Village of Arlington Heights
Plan Commission
Board Room
Arlington Heights Village Hall
33 S. Arlington Heights Road
Arlington Heights, IL 60005
May 25, 2016
7:30 PM

REPORT OF THE PROCEEDINGS OF A PUBLIC HEARING
BEFORE THE VILLAGE OF ARLINGTON HEIGHTS
PLAN COMMISSION

RE: LEXINGTON HOMES SUBDIVISION; PC# 16-004

Sheet No.
FE-3

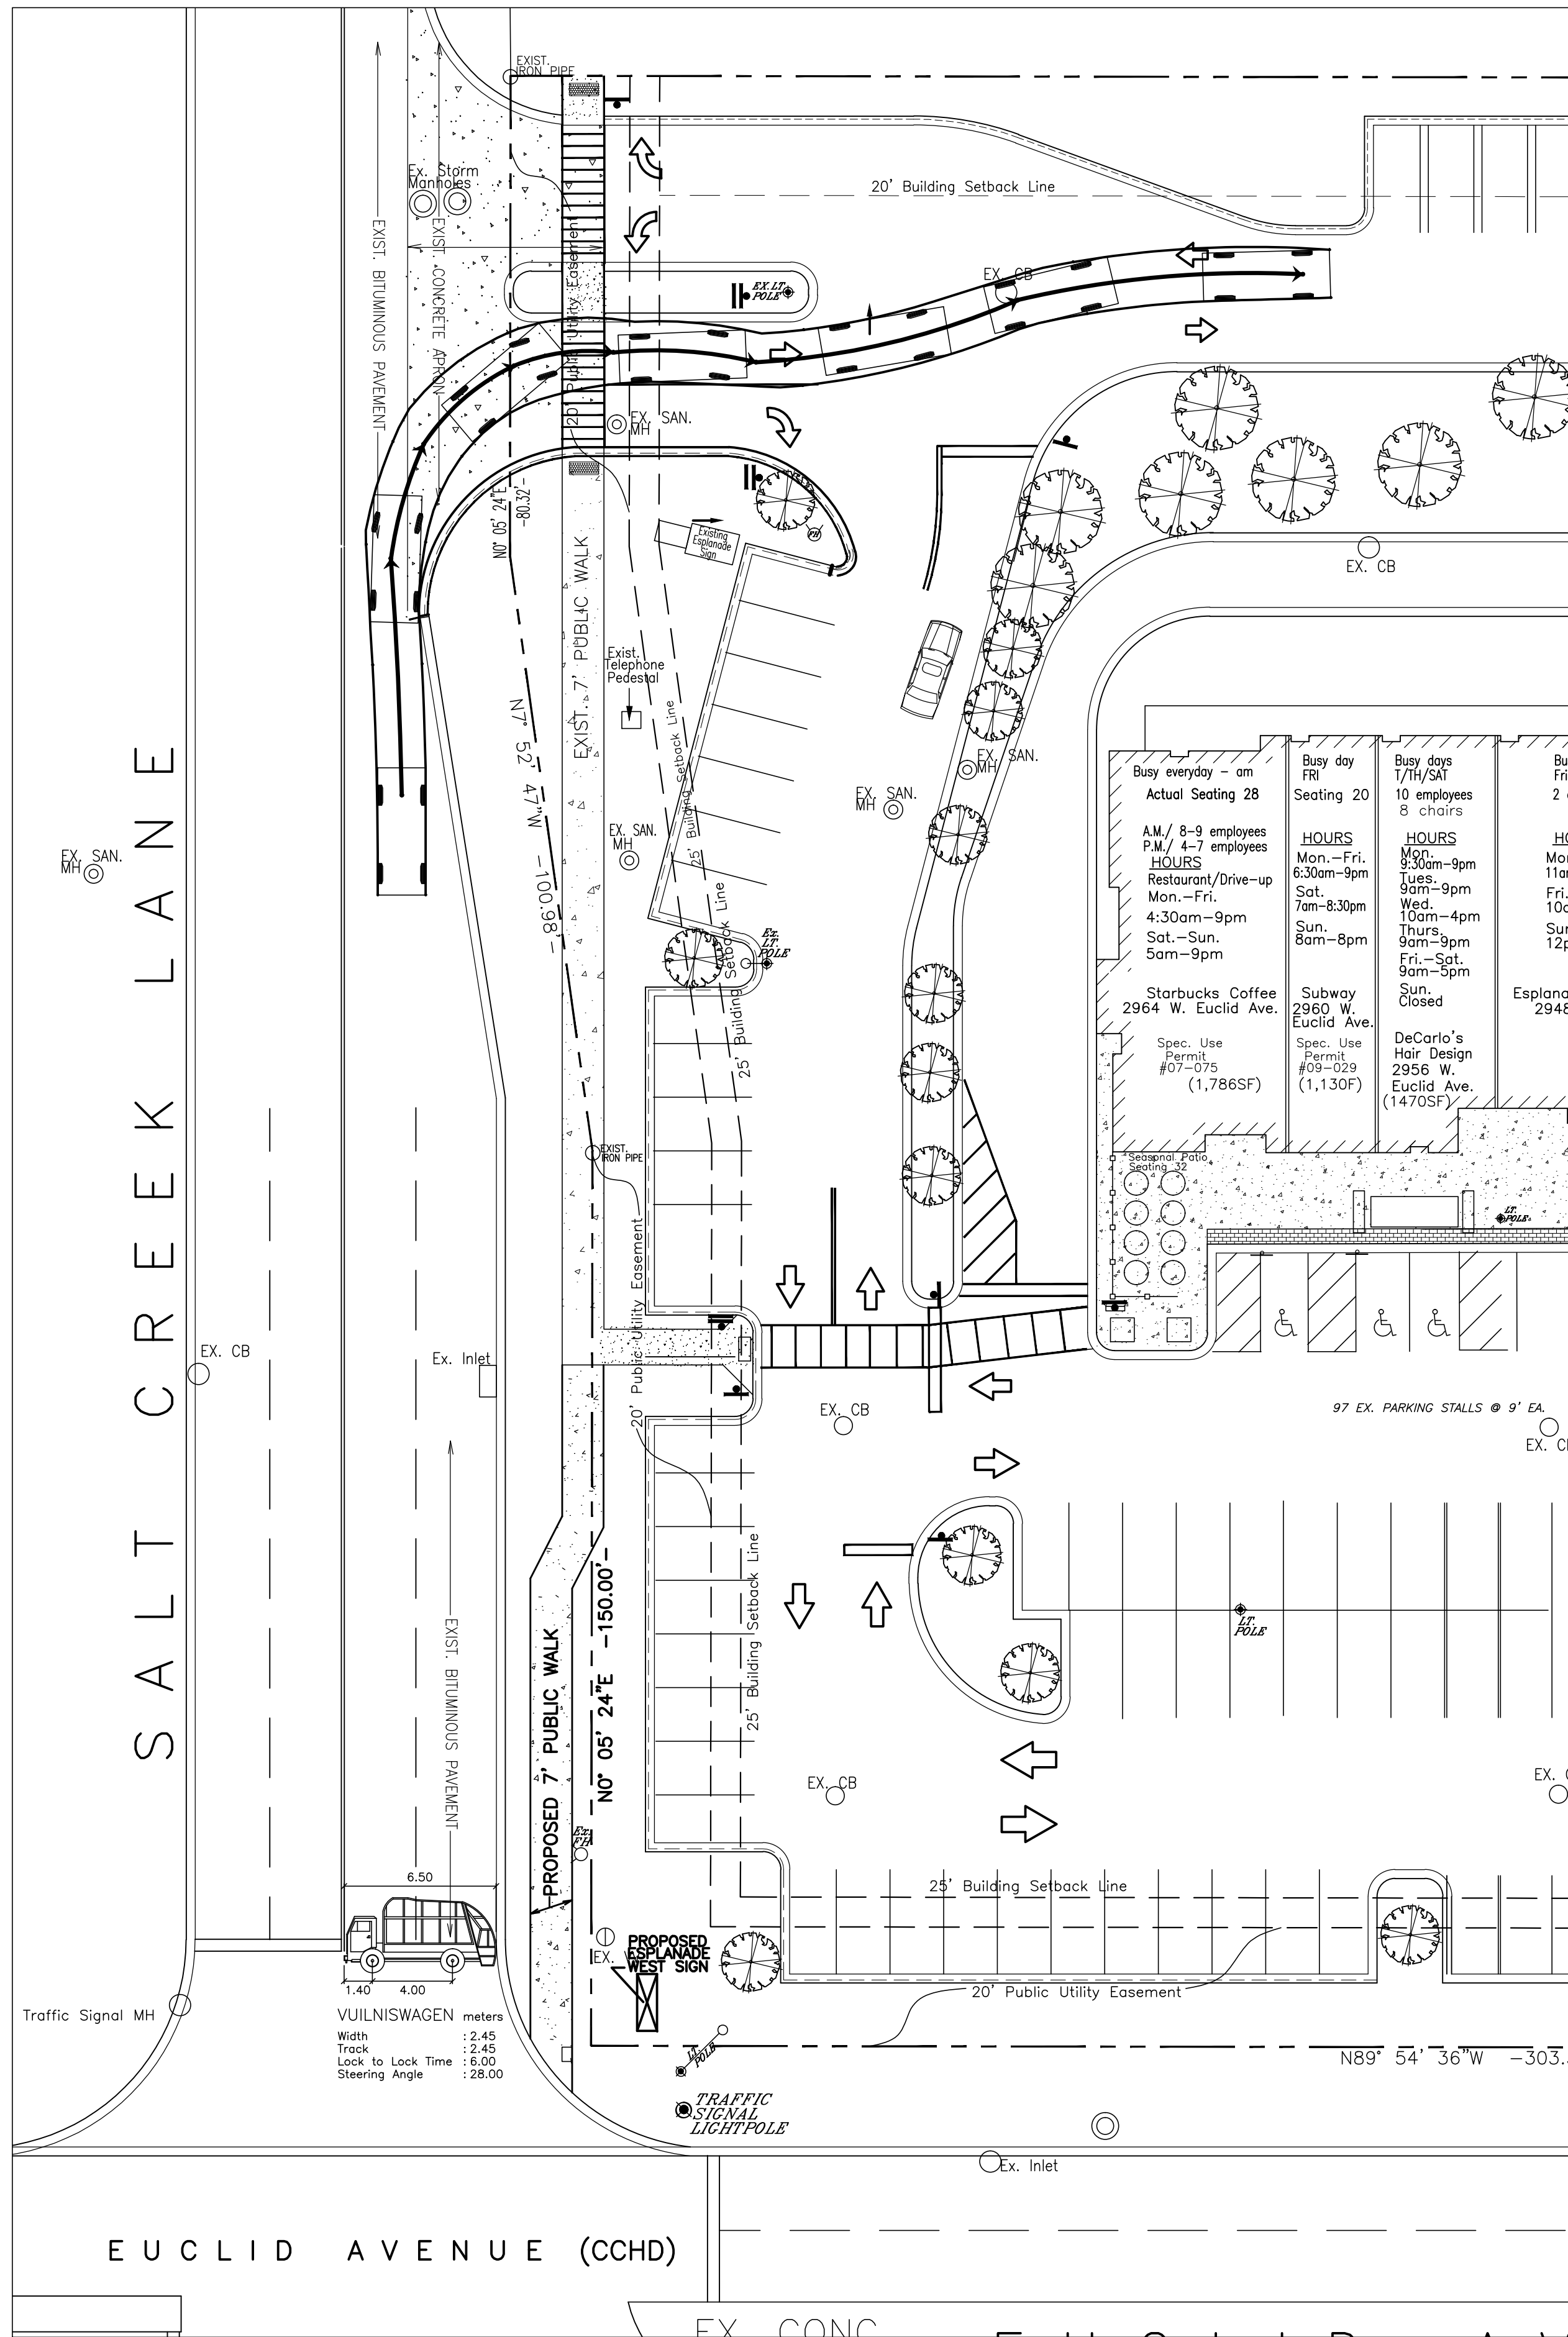
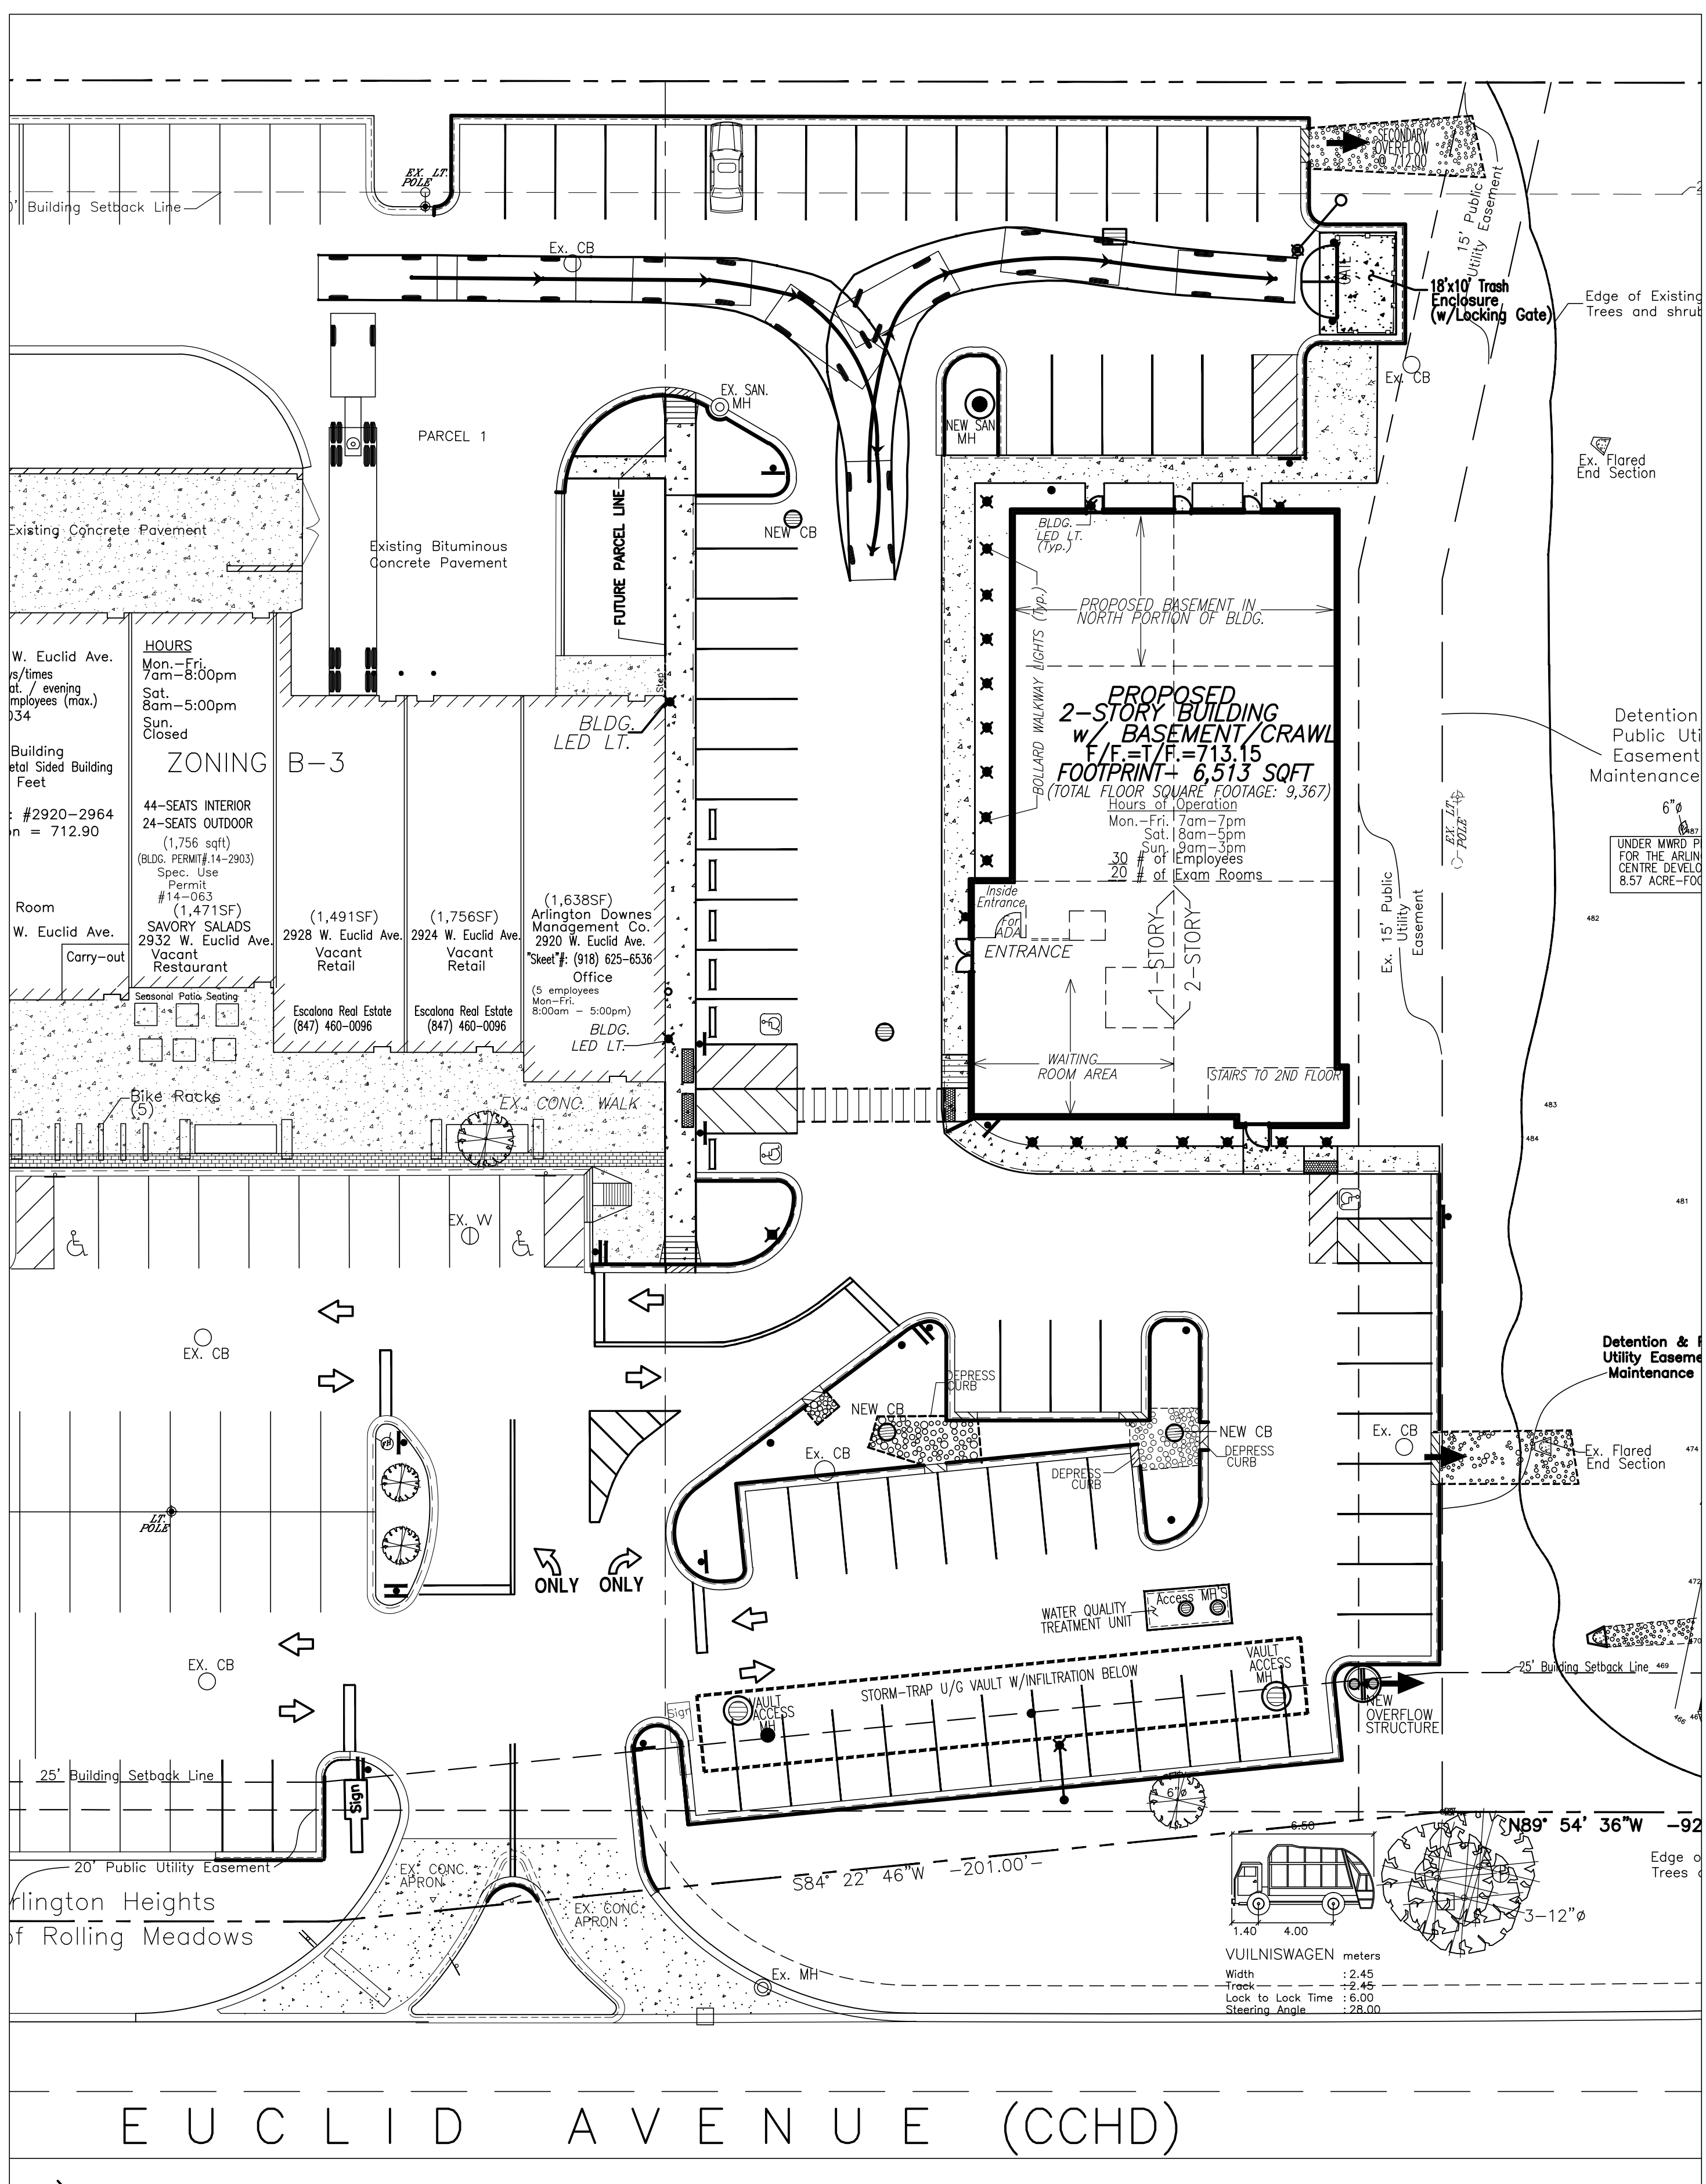
20. The Fire Truck Turning Exhibit (Sheet FE-3) uses tower truck #431.
21. Bicycle racks shall be installed near the southeast side of the proposed dental facility.
